Wolverine GSI Summary and Work Plan Review

Wolverine Community Advisory Group

PFOS Extent Map 12/21/20

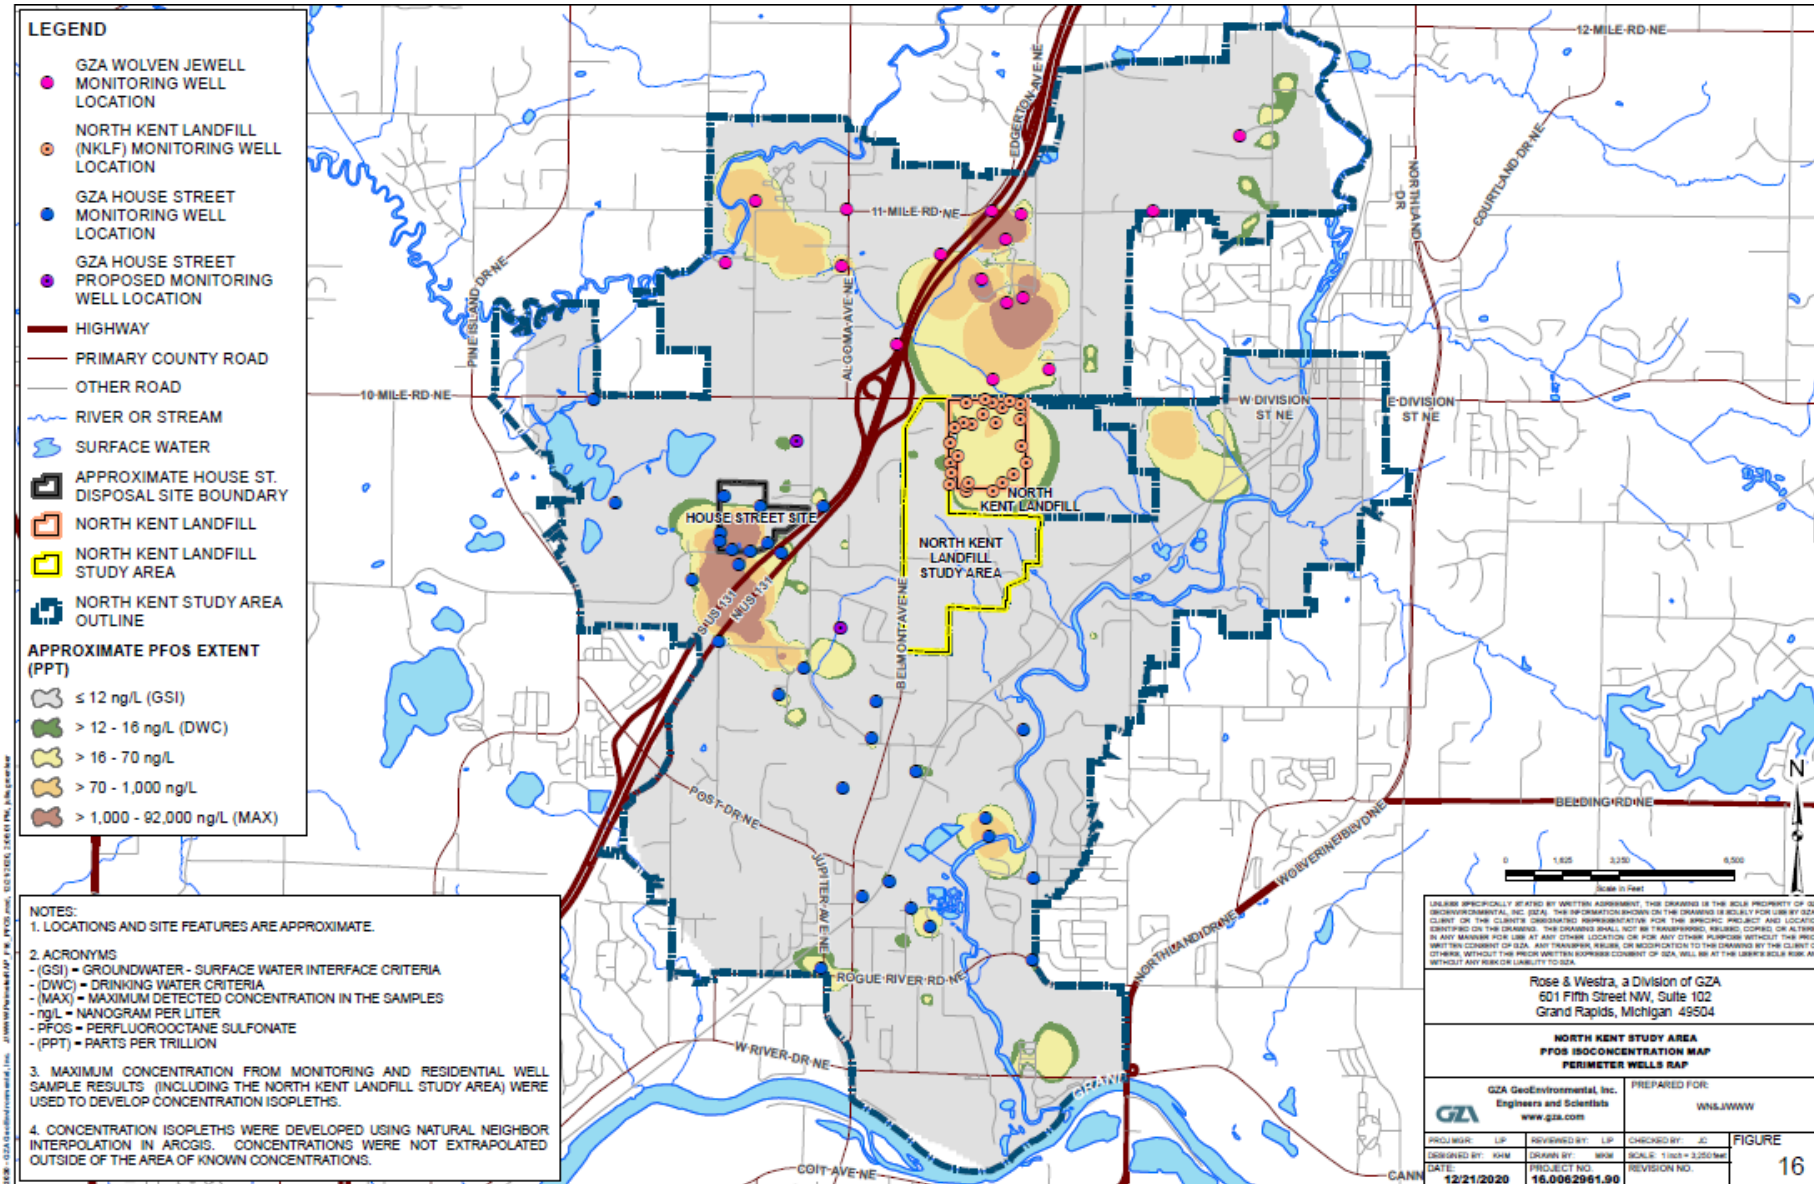
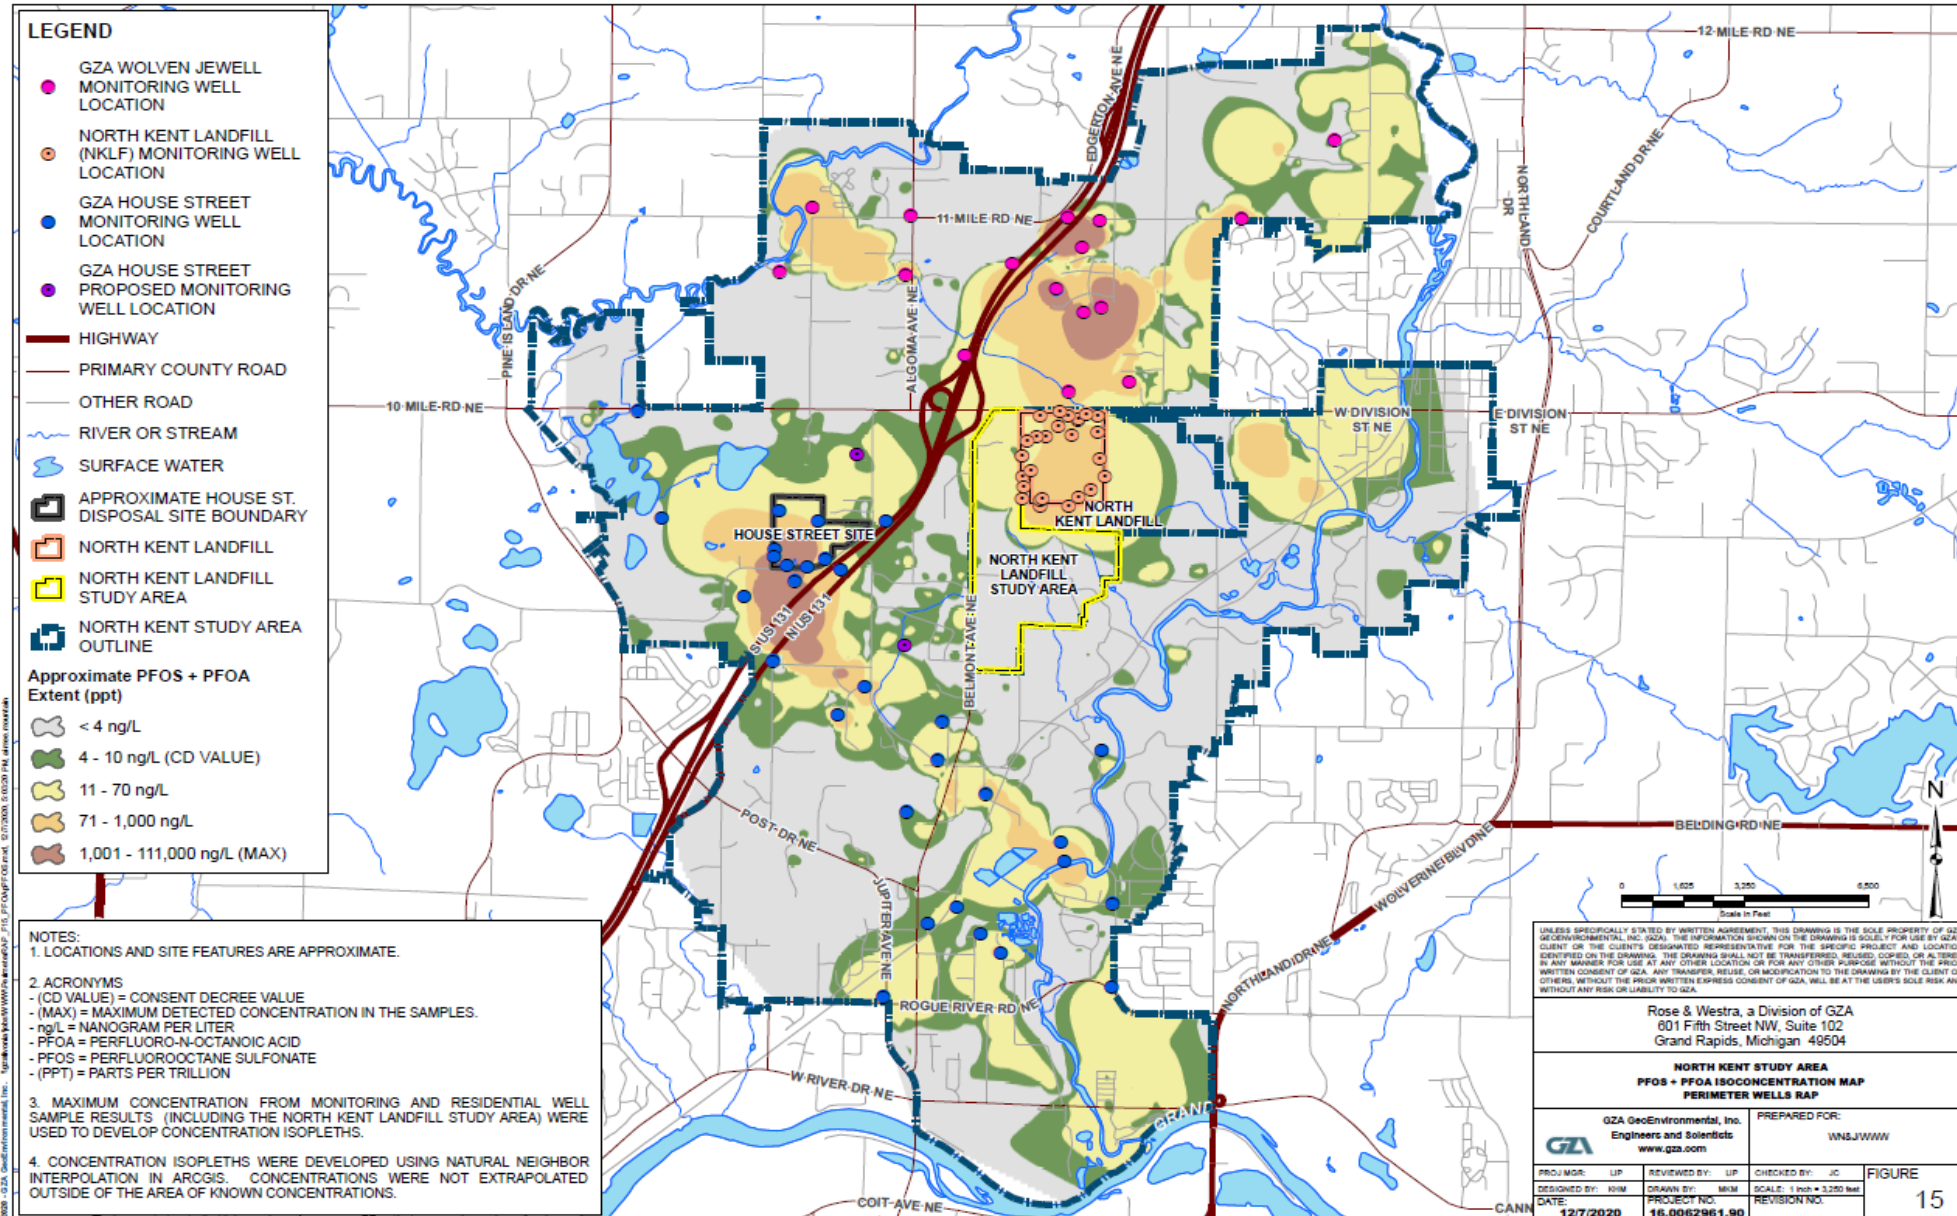
- Request the opportunity to review and comment on the pore water collection data which was omitted from the report
- Request the placement of additional GSI wells to better define the plume in contaminated areas
- Require Wolverine to produce an accurate plume map that reflects the current data showing PFOS entering the Rogue River above the GSI standard.

Wolven Jewel West

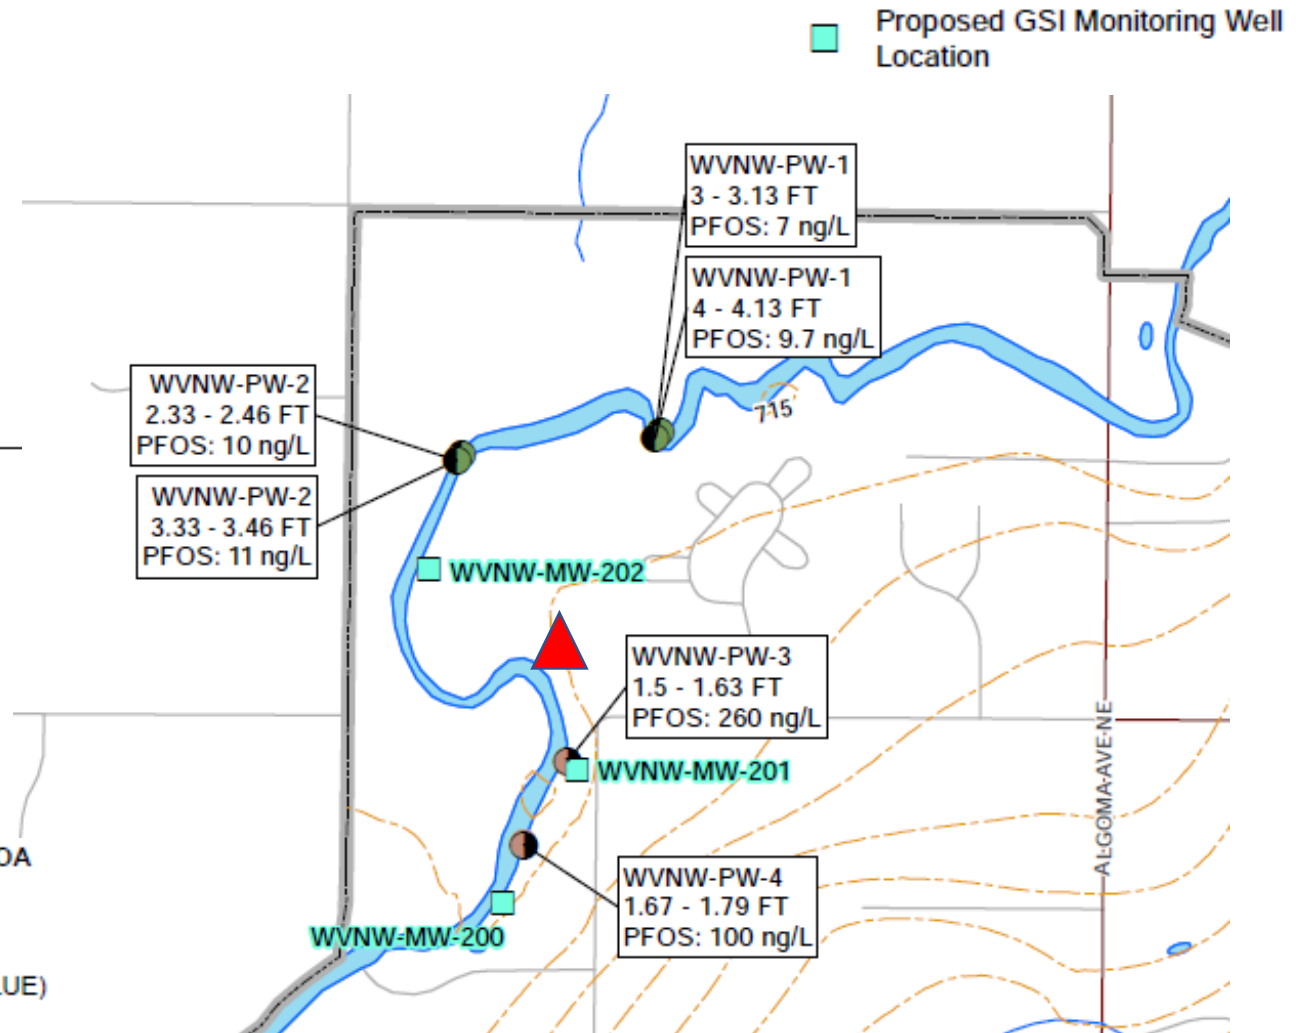
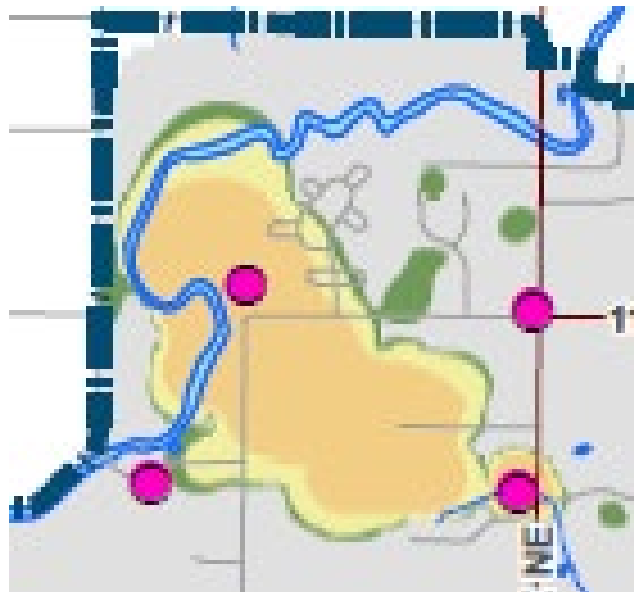
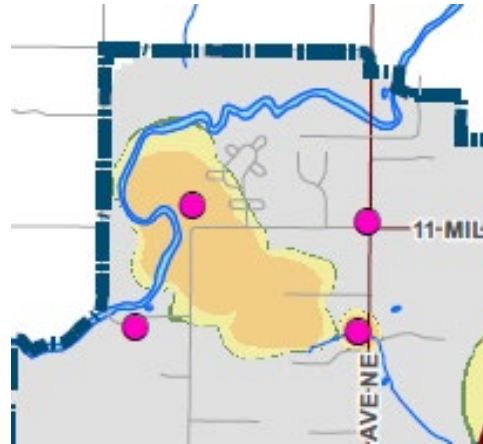
▲ Recommended GSI Well Location

Wolven Jewel East

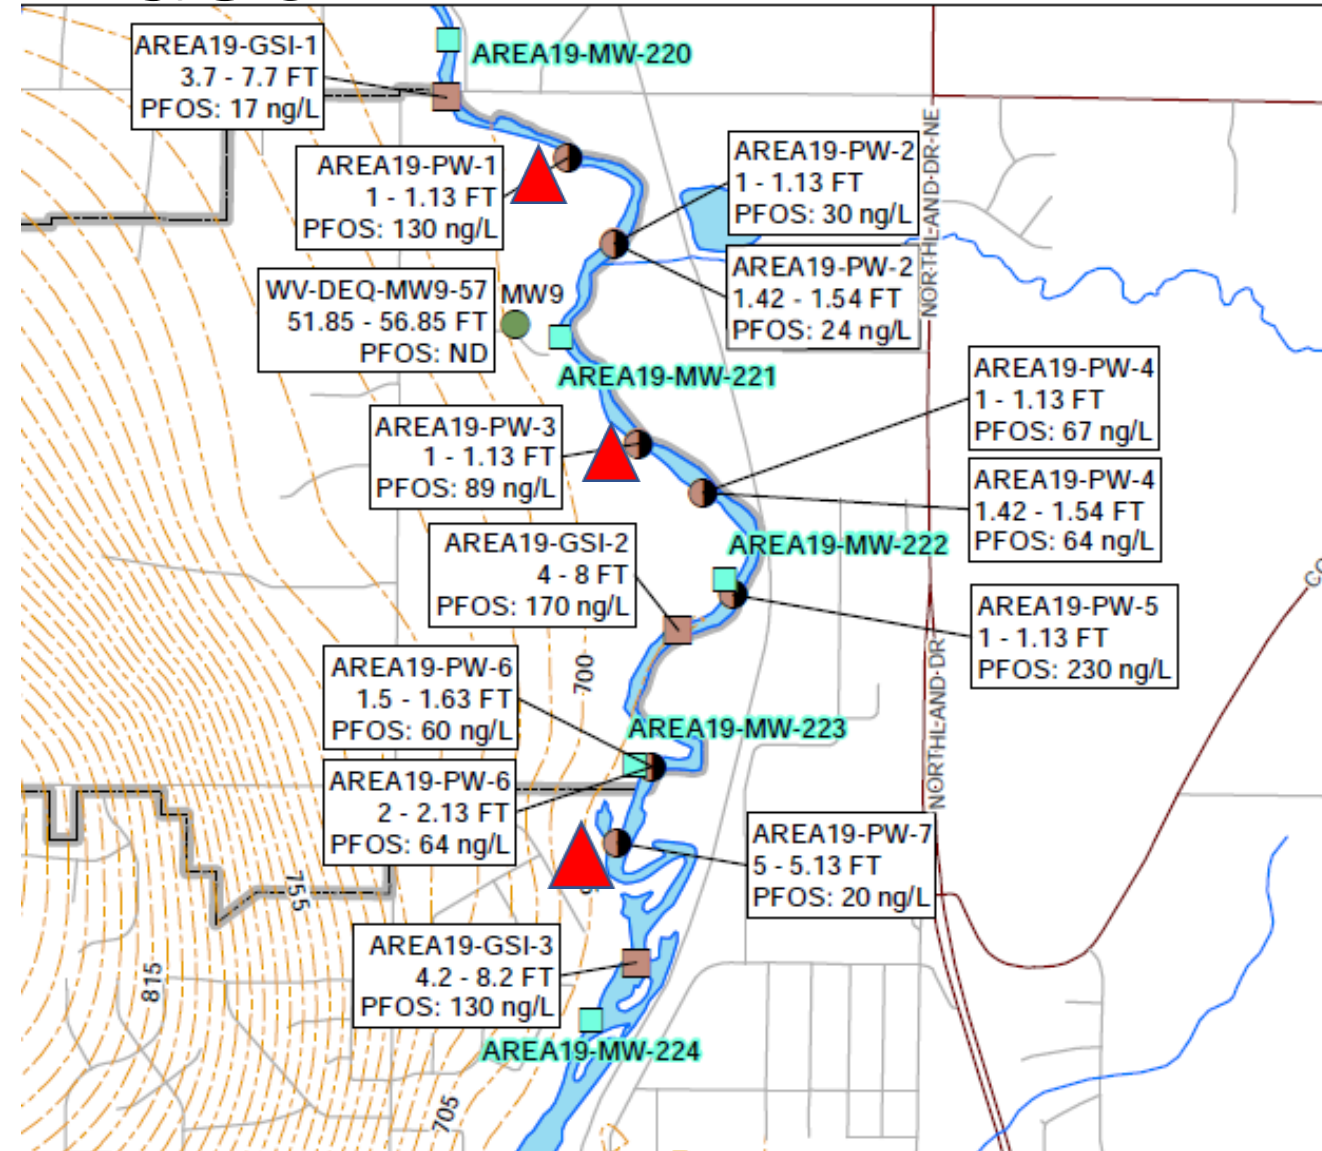
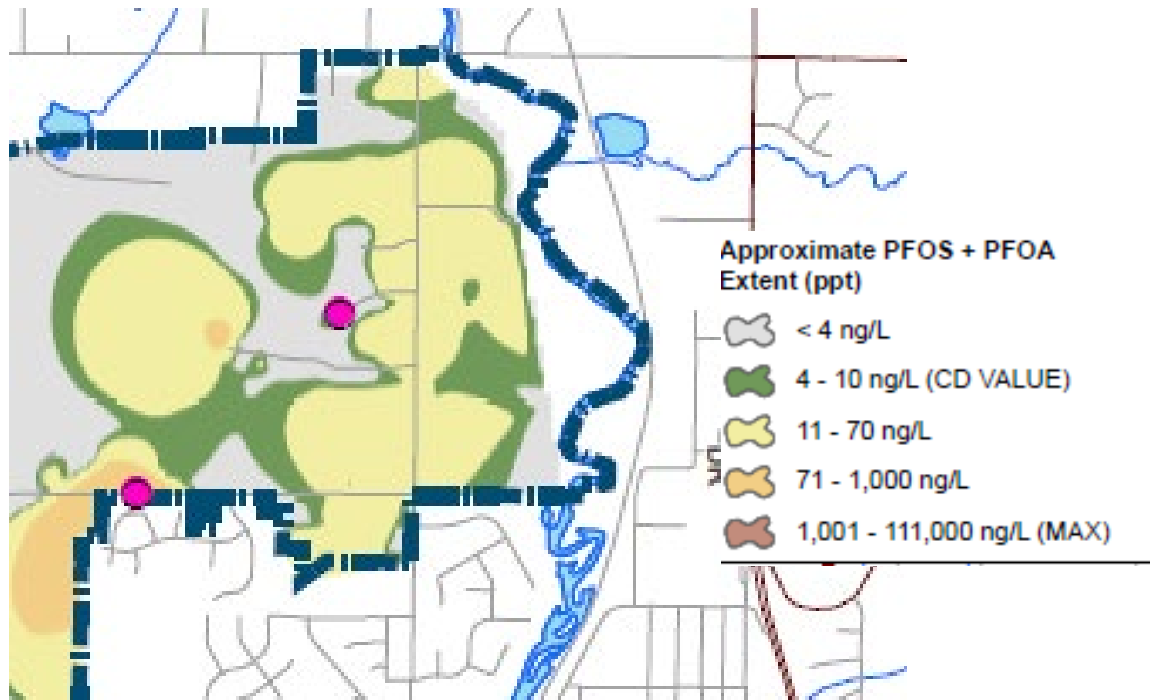
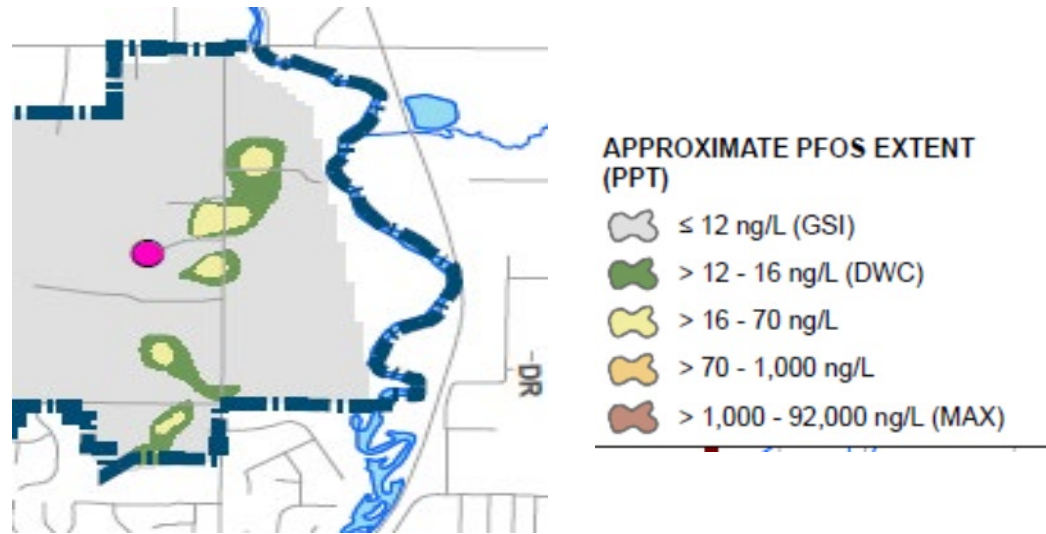
Recommended GSI Well Location

Proposed GSI Monitoring Well Location
